LAND AT PALK ROAD, HAVANT

ADDENDUM TRANSPORT ASSESSMENT

<i>Document No:</i>	043.0035/ATA/2	
<i>Status:</i>	Original	
	<i>Name</i>	<i>Date</i>
<i>Prepared by:</i>	Jessica Miller	September 2023
<i>Checked by:</i>	Tom Fisher	September 2023
<i>Approved by:</i>	Mark Smith	September 2023

<i>Rev.</i>	<i>Date</i>	<i>By</i>	<i>Summary of Changes</i>	<i>Aprvd</i>
2	06.10.23	CID	Clients Comments	JM

Figure 1: Routes to Harts Farm Way

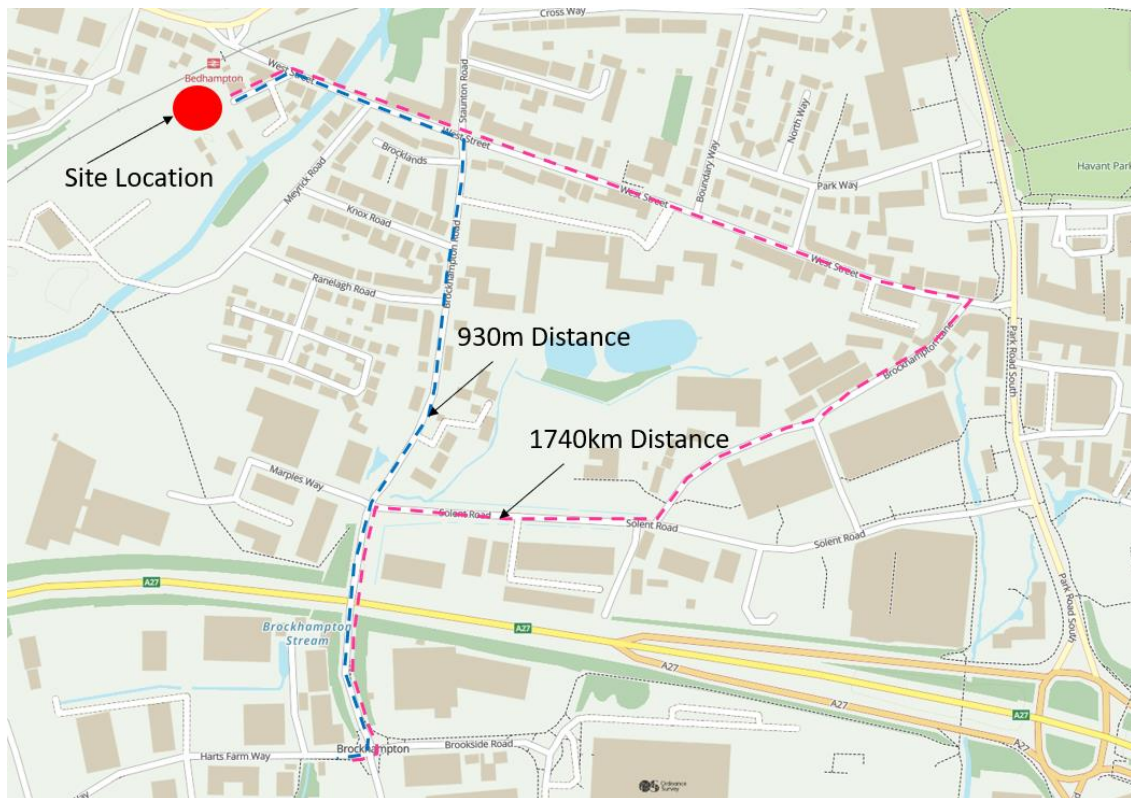
- 2.13 It is not agreed that works to improve Brockhampton Lane or Solent Road would be utilised by the proposed development when accessing Harts Farm Way. Instead, residents of the proposed development would use Brockhampton Road from its junction with West Street to Harts Farm Way. This is demonstrated in **Figure 1**.

- 2.14 Therefore, only a small portion of the HCC desired route between the Brockhampton Road/Solent Road/Marples Way roundabout and the Brockhampton Road/Brookside/Southmoor Lane/Harts Farm Way roundabout would be utilised, a circa 250m stretch, out of a total 980m based on HCC's desired route. Therefore, this route was not considered in detail within the WCHAR or TA as pedestrians or cyclists from the proposed development would not use this route. Given that only a small portion of the route would be used by residents, a fair and reasonable contribution seems sensible, as delivery of the full route would not pass the necessary planning tests being necessary or reasonable scale. It should also be noted that it is not the responsibility of the proposed development to independently solve existing deficits in infrastructure, particularly along routes which would not be used by the development.

Site Access

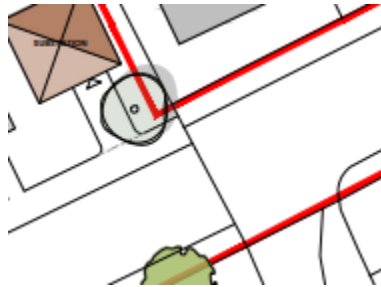
Access to the development is proposed to be a continuation of Palk Road as per the existing arrangement into the site. The existing carriageway width is circa 7.0 metres; however, Palk Road is not a consistent width, and this assessment has not taken into consideration parked cars that frequently occur on both sides of the carriageway. The operational carriageway width is therefore a concern considering the occurrence of on-carriageway parking and variable width. Concerns with the operation of Palk Road with the addition of development traffic is discussed further within this response. Within the development the carriageway width is proposed to be circa 5.0 metres as it enters the site, before narrowing further to 4.8-5.0 metres further within the site.

As requested at the pre-application stage, visibility splays should be provided at the accesses along Palk Road in close proximity to the extended Palk Road site access to ensure these accesses remain safe and suitable. This point is still outstanding and should be addressed.

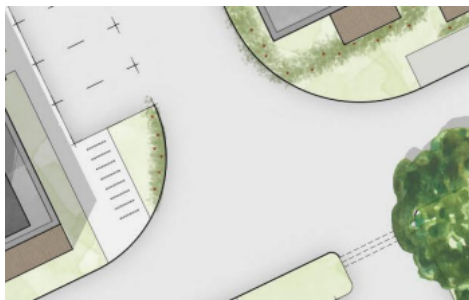
junction and the operation of the junction considering the intensification of use with the addition of development traffic. Tracking should be provided at the Palk Road/West Street junction for a delivery vehicle and car to ensure that this regular movement can be operated in a safe and suitable manner.

4.6 HCC also raised concerns with the geometry of the Palk Road/West junction and the operation of the junction considering the intensification of use with the addition of development traffic. Tracking was requested at the junction to show a delivery vehicle and car passing in a safe and suitable manner. Whilst this concern is noted and the tracking exercise completed and attached as **Appendix I**, it is worth re-iterating that the proposed development is a brownfield development and had been in operation as B8 storage for over 100 years for various land uses/owners. A commercial land use still remains on the site immediately adjacent to the east of the proposed development. Therefore, the junction has been operating satisfactorily for many years with much larger vehicles likely to have utilised the Palk Road/West Street junction without any recorded Personal Injury Accident (PIA) incidents. Therefore, the change of use from commercial to residential would reduce the number of larger vehicles using this access and thus provide a betterment than the previous situation. The tracking shown in **Appendix I** shows that a car and delivery vehicle can operate suitably and safely at the access.

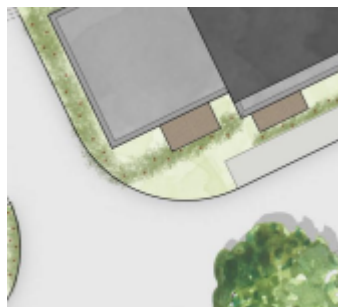
No visibility splays have been provided for the internal road network. Forward visibility splays should also be provided for bends at a minimum of 25m for a 20mph design speed. It is noted that the location of hedge planting and the corner of apartment block A would currently block any achievable visibility as shown below and the layout should be revised.

The raised crossing point within the site has no ramp details and these should be provided for comments on their suitability.

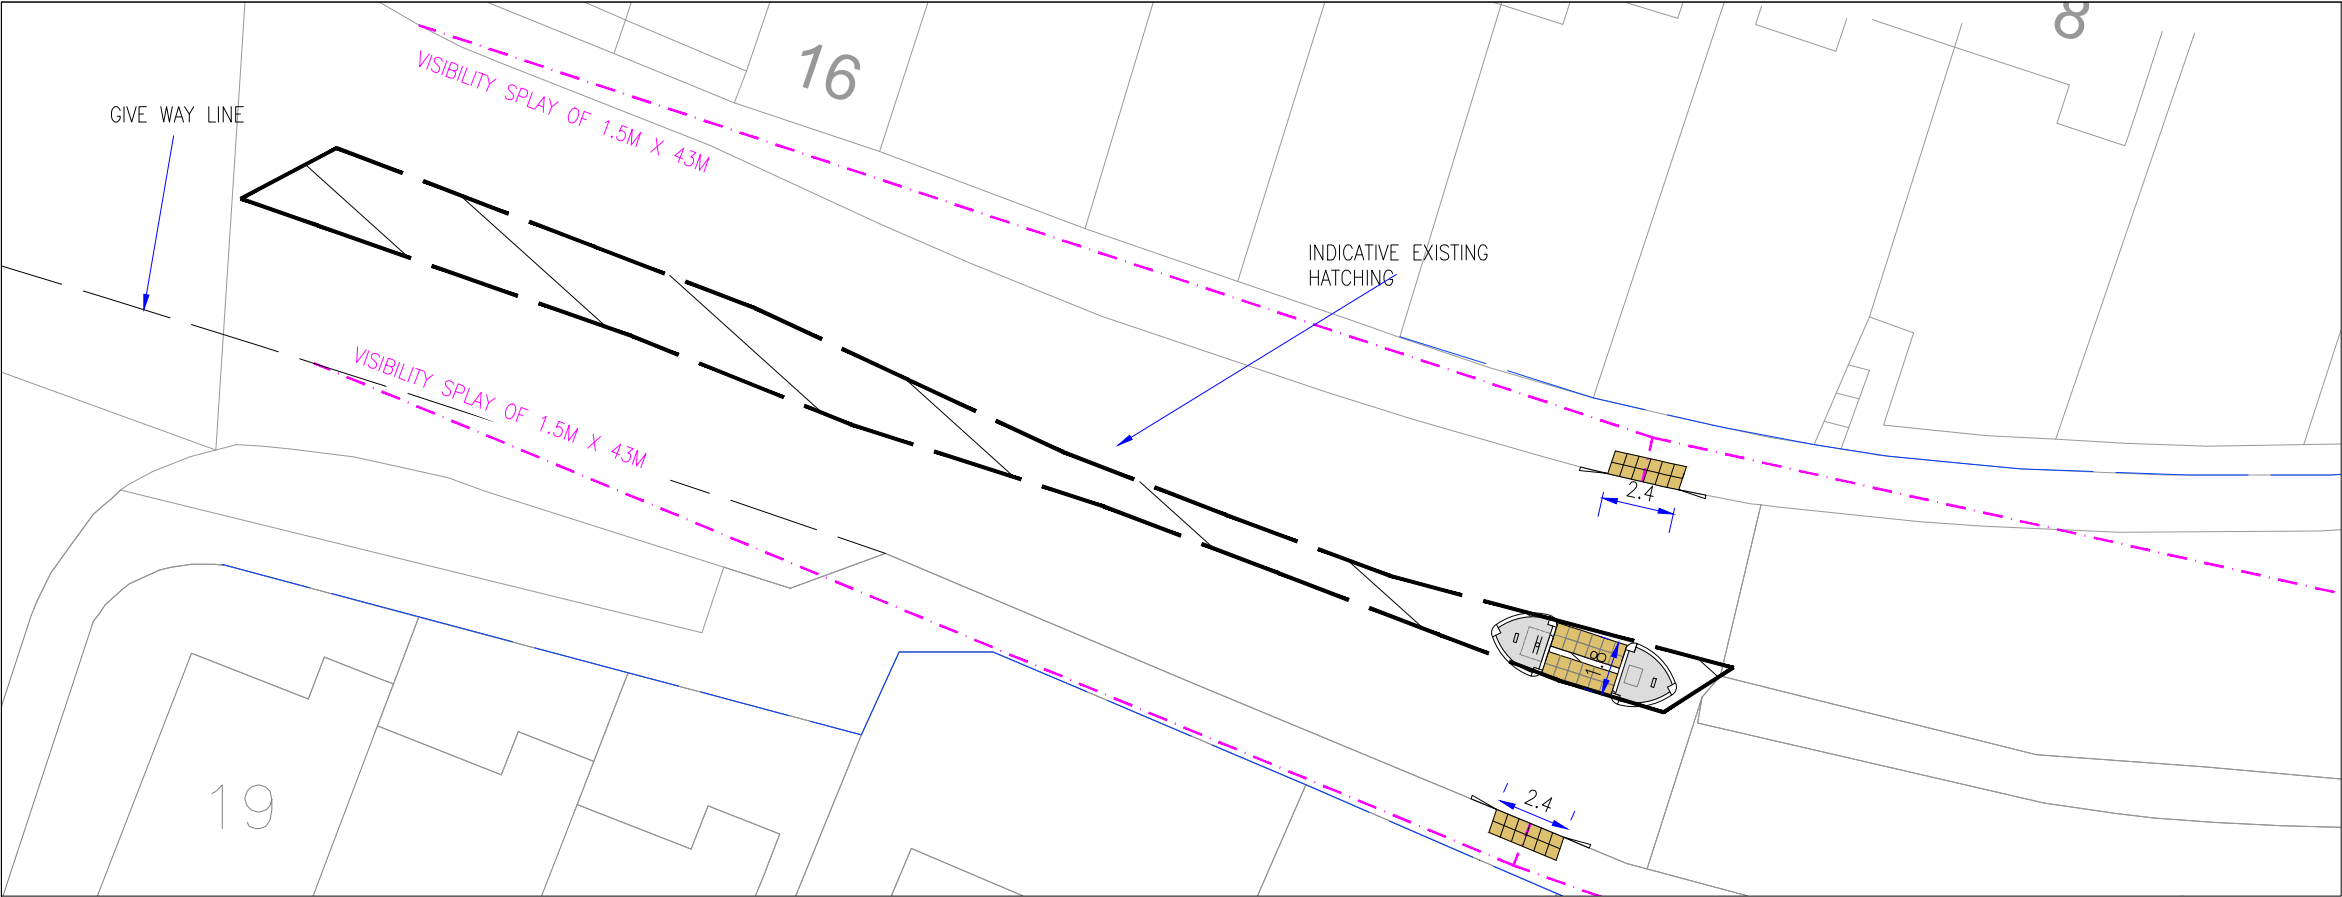
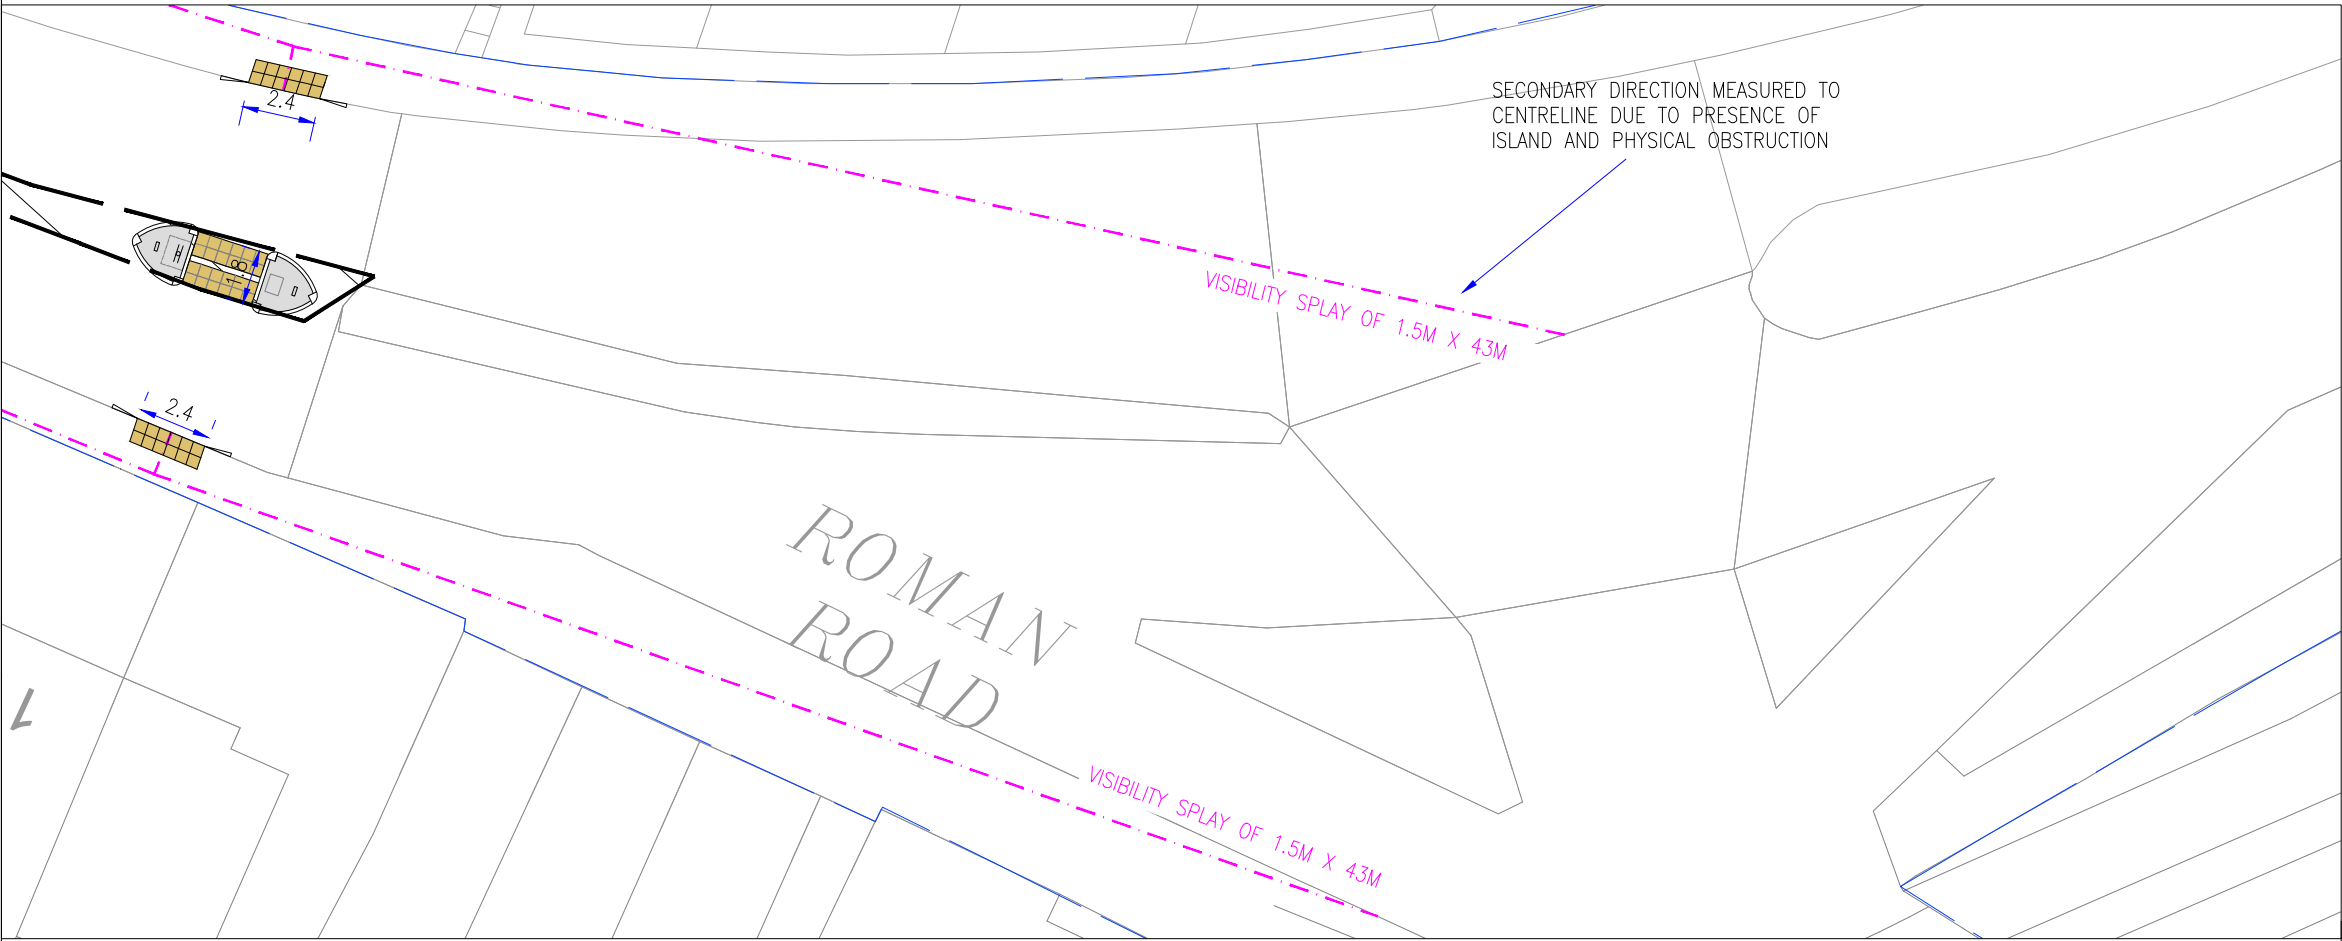
At the Palk Road/West Street junction a dropped kerb crossing is present however tactile paving is missing. This should be provided. As mentioned during pre-application discussions, the applicant has proposed a crossing point in the vicinity of the Palk Road/West Street junction as shown on drawing 043.0035.003 to overcome the deficits in crossing provision along West Street. The proposed crossing is not regarded to be in the most appropriate location considering this will require the extension of the existing TRO along West Street, the removal of 3 existing parking spaces in front of No1 Brook Villas and removal of the existing guard rail. The Highway Authority are not satisfied that the TRO process would likely be successful in this location which is discussed further within this response. Further consideration should therefore be given to the

- 2.4 The location of the standalone crossing point along West Street has been raised as a concern by HCC highways with a recommendation for the crossing point to be relocated closer to the Meyrick Road/West Street junction. The same issues exist in this location with the presence of on-street vehicle parking on both the northern and southern sides of West Street and therefore the proposed location also does not address the concerns. Therefore, a crossing point has been shown to the west of the Palk Road/West Street junction which can be designed to standards without any conflict of parked cars in the visibility splay. This is shown in **Appendix C**.

- 2.5 It should be noted a crossing in this location would only result in a 10-15m detour off a potential desire line which is not considered to result in a severe impact on its useability. Furthermore, whilst this crossing point is moved north and there may be concerns over the queuing vehicles resulting from the level crossing to the west, when vehicles are queued this is because the barriers are down and thus no traffic is traveling along West Street in either direction at this location and therefore pedestrians are able to cross safely.
